139 FERC ¶ 61,247
UNITED STATES OF AMERICA
FEDERAL ENERGY REGULATORY COMMISSION

Docket Nos. RM12-6-000 and RM12-7-000

Revisions to Electric Reliability Organization Definition of Bulk Electric System and
Rules of Procedure

ACTION: Notice of Proposed Rulemaking.

Figure 1

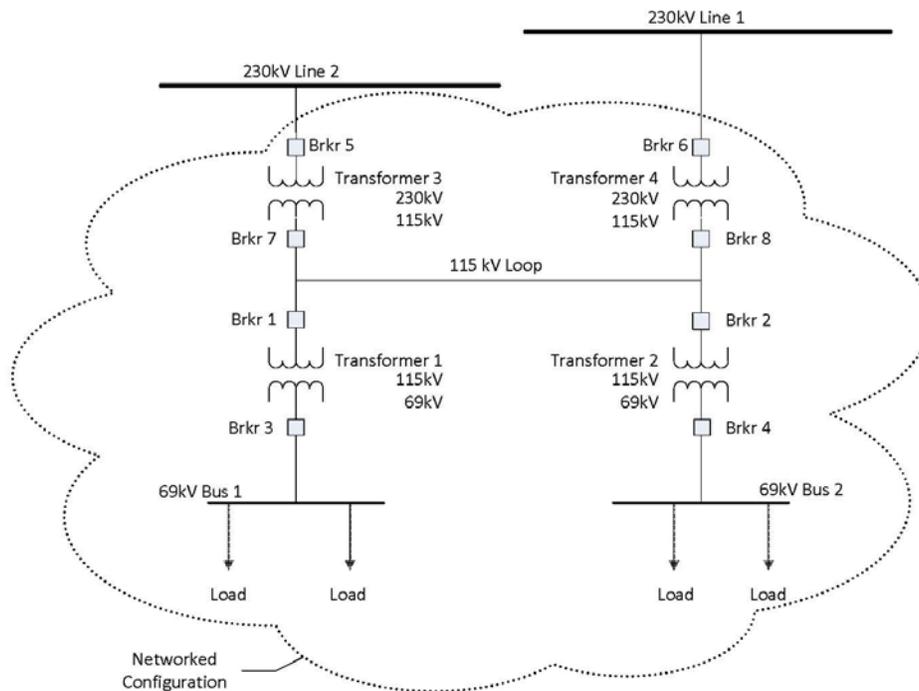
79. Figure 1 below depicts facilities configurations in which all of the 230 kV and 69 kV transmission elements emanate from a single point of connection of 100 kV or higher. The Commission seeks comment on whether each of the radial systems shown in figure 1, the 230 kV elements above each transformer to the point of connection to each 230 kV line, respectively, are excluded from the bulk electric system pursuant to exclusion E1.

Figure 2**Networked Configuration w/115 kV Loop**

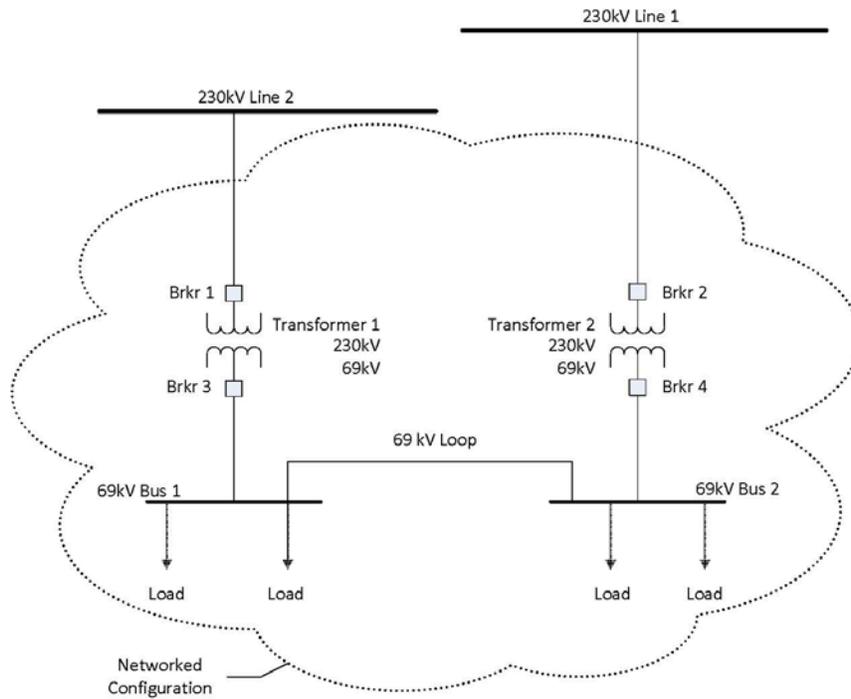
80. Another scenario shown in figure 2 below depicts a configuration containing a 115 kV loop, with the configuration emanating from two points of connection of 100 kV or higher. We seek comment whether, in this configuration, the 115 kV and 230 kV elements above Transformers 1 and 2 to the points of connection to the two 230 kV lines would be excluded from the bulk electric system pursuant to exclusion E1. Is the configuration shown in figure 2 more appropriately analyzed pursuant to the “local network” exclusion E3 and, if so, what if any elements operated at or above 100 kV would be excluded pursuant to exclusion E3?

Figure 4
69 kV Networked Configuration with Normally Open Switch

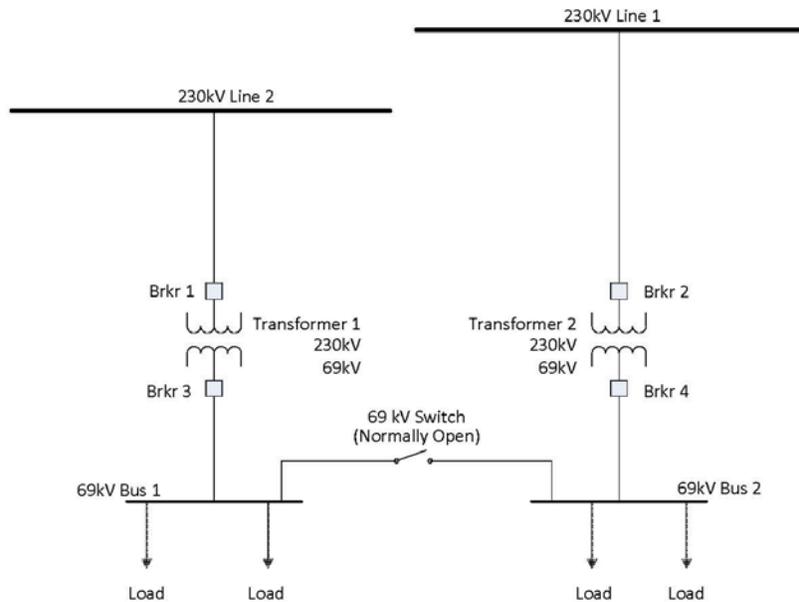
86. Figure 4 below illustrates a configuration with a normally open switch.

switch' in such configuration is well understood in the electric utility industry.”¹⁰⁵ We seek comment on NERC’s characterization and whether the phrase “normally open” is subject to interpretation or misunderstanding, or whether a “normally open” configuration is potentially difficult to oversee. Further, we seek comment on the need of transmission operators or other functional entities to study the system impacts of the closing of a “normally open” switch, or to take other steps to ensure awareness of the impacts of the loop that is created by the closing of the switch if the closed loop is not included as part of the bulk electric system.

Figure 5**Networked Configuration w/69 kV Loop**

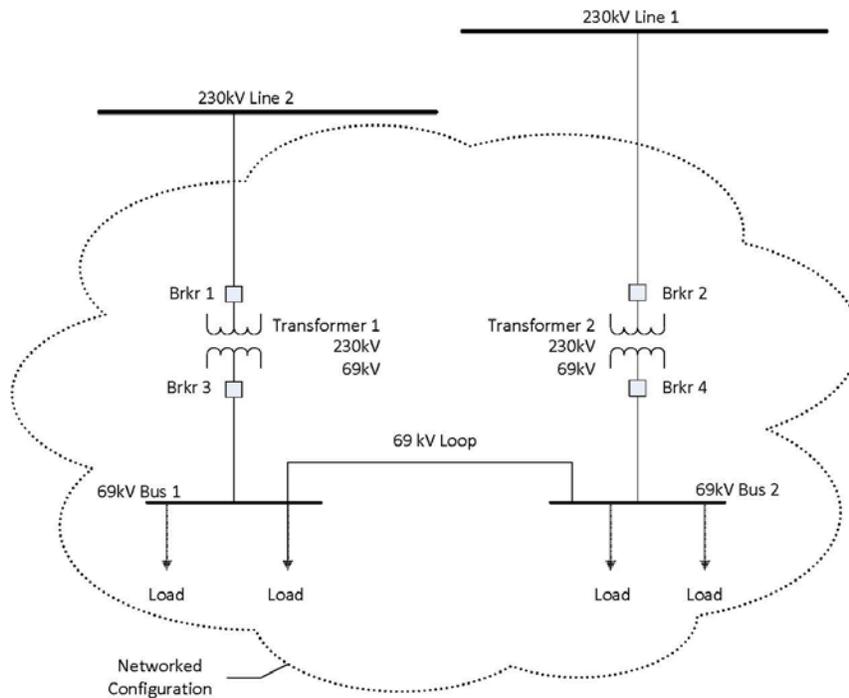
95. As stated above, exclusion E3 defines local networks as “[a] group of *contiguous* transmission Elements *operated at or above 100 kV but less than 300 kV* that distribute power to Load rather than transfer bulk-power across the interconnected system.” While the local network exclusion applies to contiguous transmission elements operating at a minimum of 100 kV, it is unclear how the exclusion applies to a looped lower voltage system. For example, figure 5 depicts a 69 kV looped system emanating from two points of connection at 100 kV or higher.

The configuration in figure 5 depicts a group of elements that are contiguous through a 69 kV loop. We seek comment whether the configuration in figure 5 qualifies as a local network and, in particular, whether the configuration satisfies the condition that a local network consists of “a group of *contiguous* transmission Elements *operated at or above 100 kV...*”
